# Site Accessibility Evaluation

**Fire Station 13**  
**1475 Cresta Rd**  
**Colorado Springs, CO**  
**80906**

**Accessibility Evaluation**

SUBJECT: Fire Station 13 Self-Evaluation

**Finding: 1**

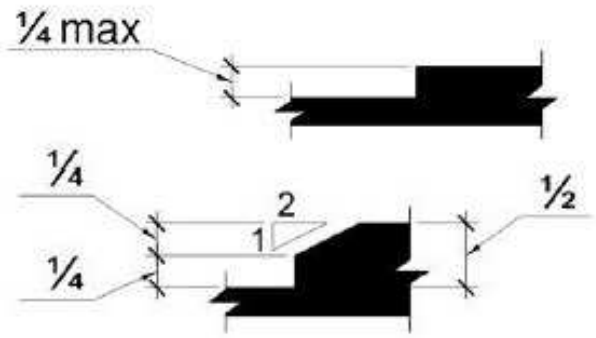
The walkway contains abrupt vertical edges and/or variations over a 1/4 inch.

There is 3-3/4" vertical displacement at the sidewalk panel containing the storm drain.

Remove and replace the sidewalk panel to provide a level route.

### Finding: 2

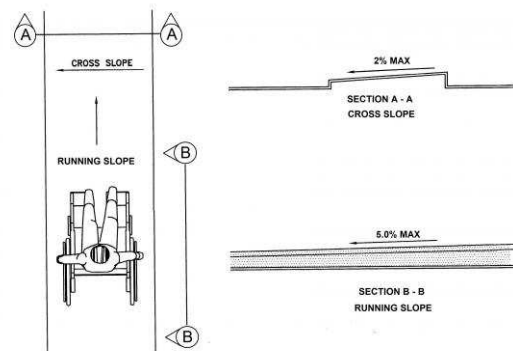
The accessible path of travel contains cross slopes greater than 2%.

The sidewalk has 5.2% cross slope.

Remove and replace the sidewalk panels to provide 2% maximum cross slope across driveway if feasible.

### **Finding: 3**

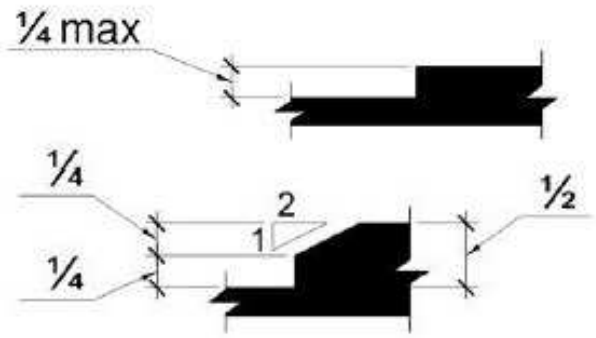
The walkway contains abrupt vertical edges and/or variations over a 1/4 inch.

There is 1/2" vertical displacement where the sidewalk meets the driveway.

Grind to less than 1/2" bevel.

**Finding: 4**

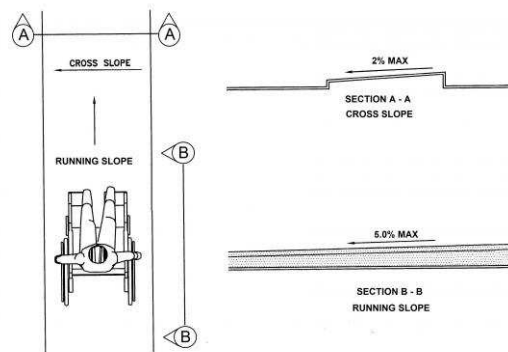
The accessible path of travel contains cross slopes greater than 2%.

The sidewalk has 5.7% cross slope across four concrete panels.

Remove and replace the sidewalk panels to provide maximum 2% cross slope.

**Finding: 5**

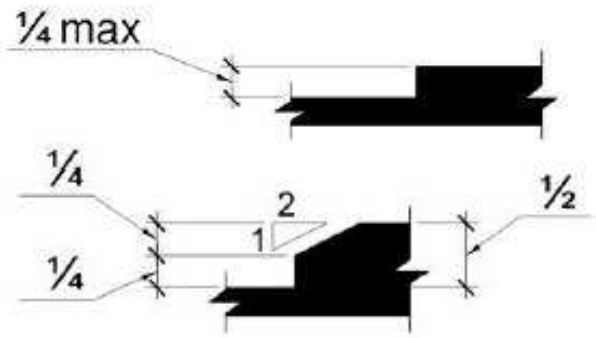
The walkway contains abrupt vertical edges and/or variations over a 1/4 inch.

There is up to 1-3/4" vertical displacement at the concrete panel with the storm drain.

Remove and replace sidewalk panels.

### Finding: 6

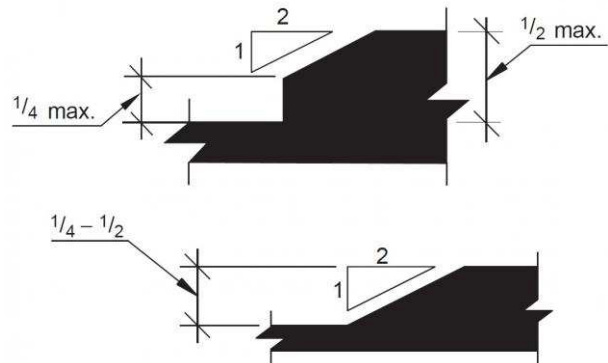
The change in level where the gutter meets the curb ramp is greater than 1/2 inch. This curb ramp is at La Veta Way.

Also, ramp lays funky with detectable warning placement. Should be oriented to direction of travel. Creates rough pivot area at domes.

Also, gutter pan to road has vertical displacement.

There is over 1/2" vertical displacement between the curb ramp and the gutter.

Replace Ramp

### Finding: 7

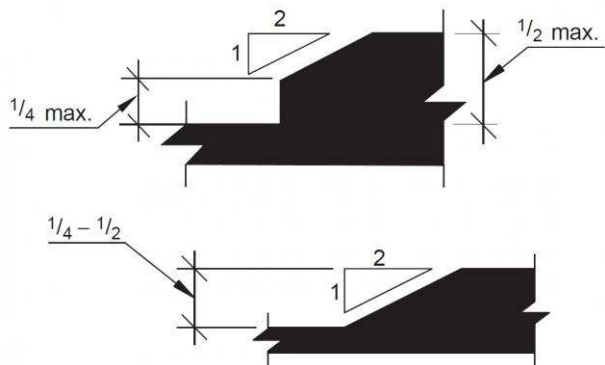
The change in level where the gutter meets the curb ramp is greater than 1/4 inch. This curb ramp crosses Cresta Rd to the high school.

There is over 1/2" vertical displacement between the curb ramp and the gutter.

Grind to flush if feasible. If not, to the maximum extent feasible.

Finding: 8

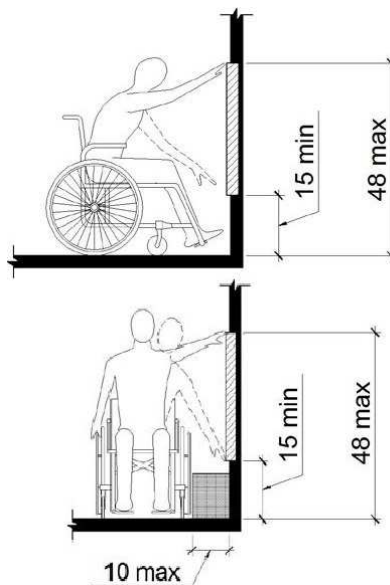
The door bell is not positioned correctly for either a side or front approach.

The door bell is mounted at 57".

Lower the door bell to at or under 48".

**Finding: 9**

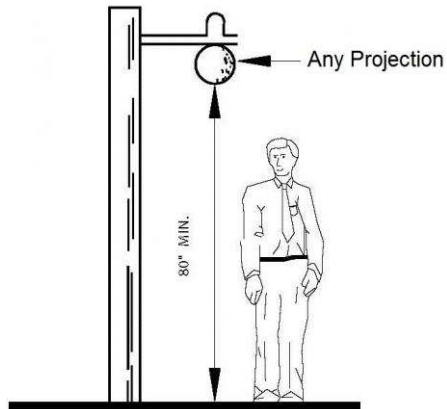
The plantings extend down too close to the route of travel.

**The plantings adjacent to the sidewalk overhang the sidewalk.**

Keep the adjacent plantings trimmed.

### Finding: 10

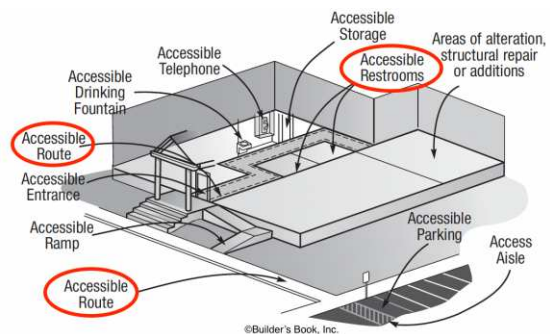
The restroom facilities serving the facility are not on an accessible route and are not accessible. The restrooms are not intended for public use.

The restrooms are not accessible.

As long as the restrooms are not for public use, they do not need to be made accessible.
